ADDENDUM NO. 1
TO THE
DRAWINGS AND SPECIFICATIONS
FOR THE

MADISON STREET SIDEWALK (3RD STREET TO PROSPECT STREET))
PW 09-24

South Madison Street - Prospect to Third Sidewalk Improvements

Addendum No. 1

ADD1-C1

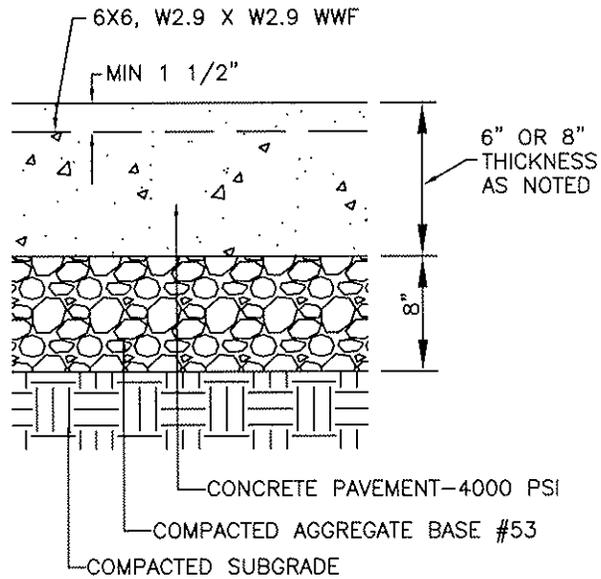
Sheet C601

1. Revise Detail 5/C601 as indicated in the attached sketch ADD1-C1
2. Contractor to install a self leveling polyurethane, neoprene, or vinyl sealant on all expansion joints.
